MAINE TURNPIKE AUTHORITY

ADDENDUM NO. 1

CONTRACT 2021.07

**EXIT 45 – INTERCHANGE
RECONFIGURATION**

SHEET NUMBER: GT-05
285 OF 431

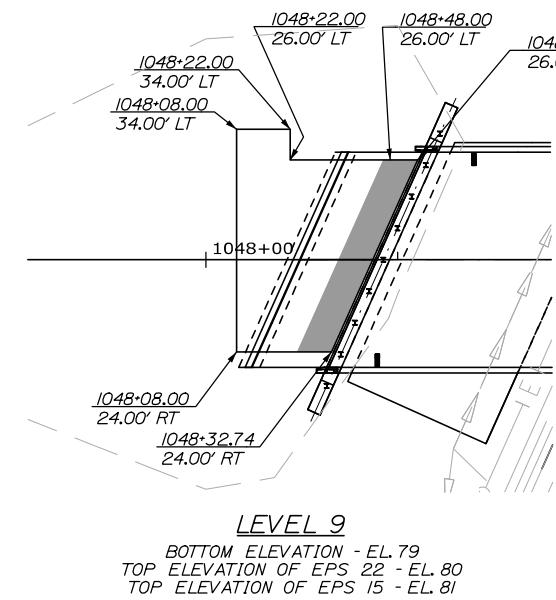
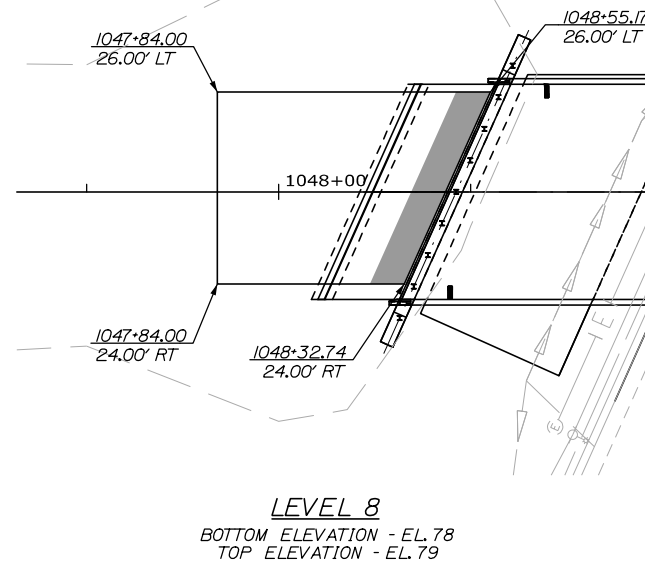
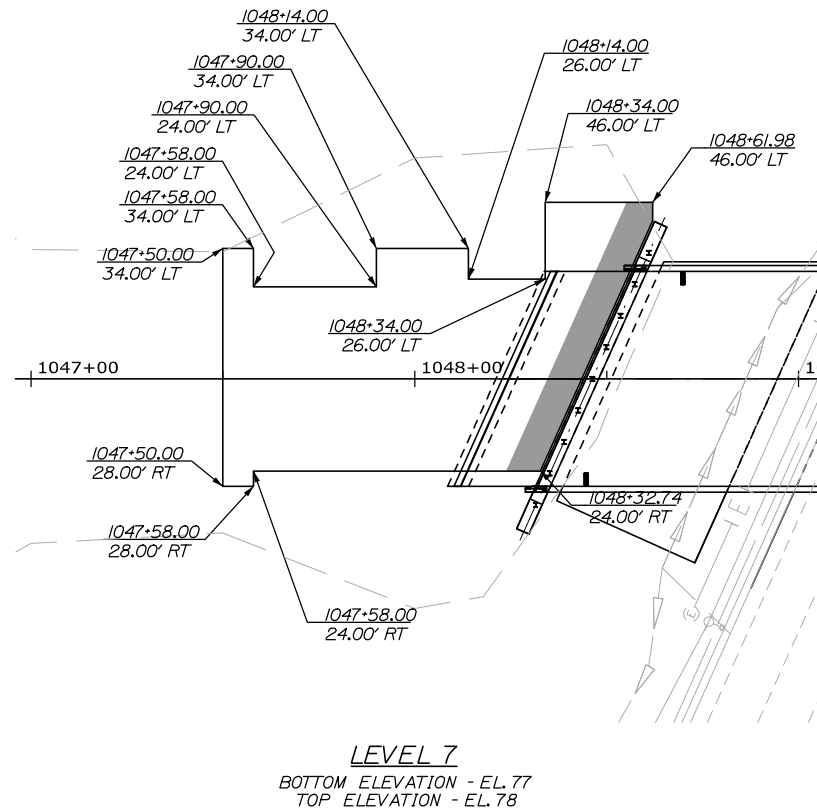
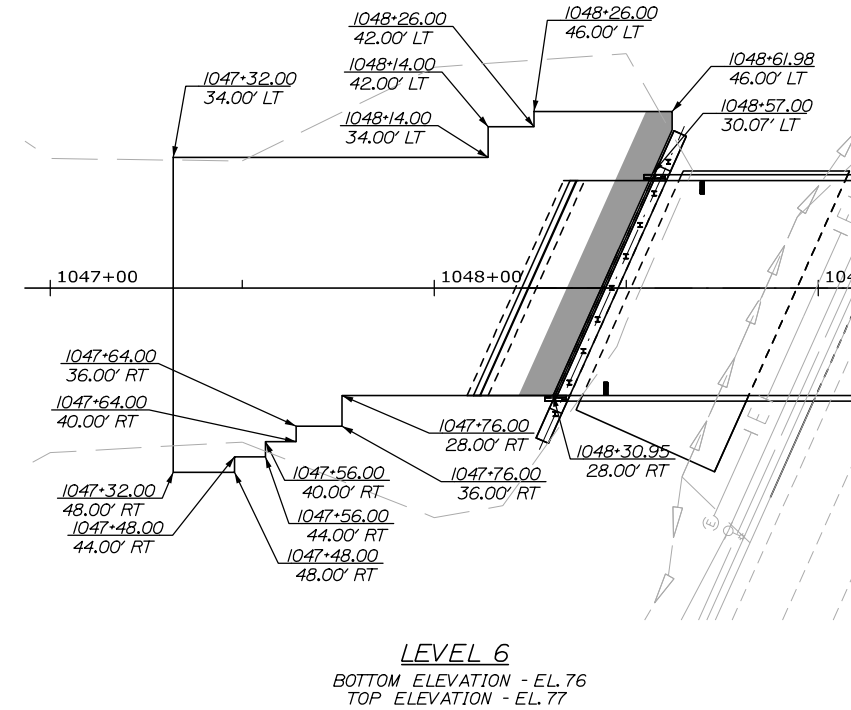
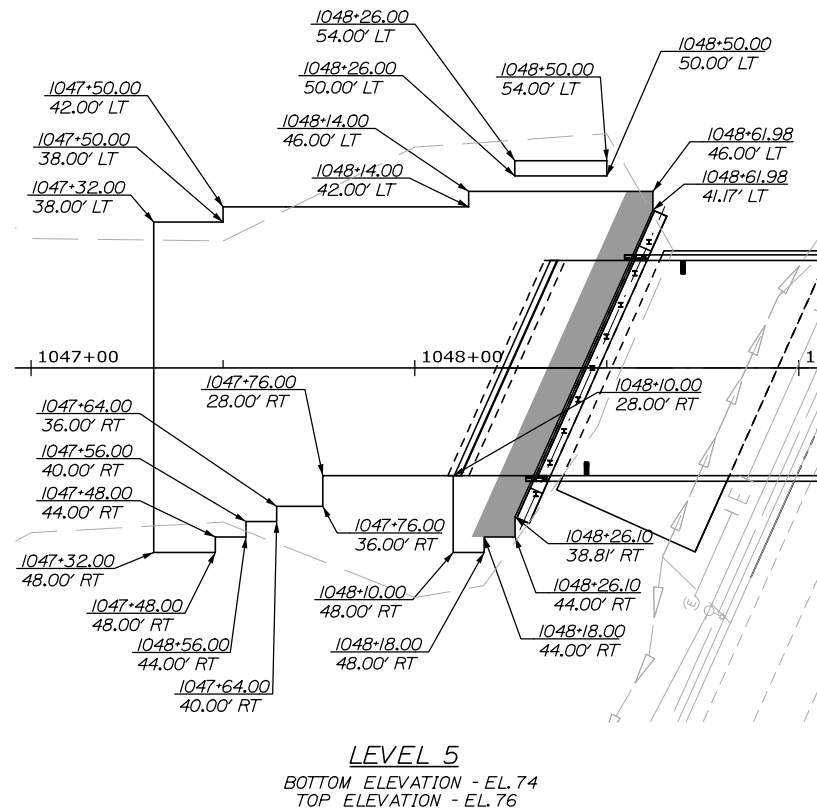
No.	Revision	By	Date
1	UPDATED NOTE	JRH	1/21
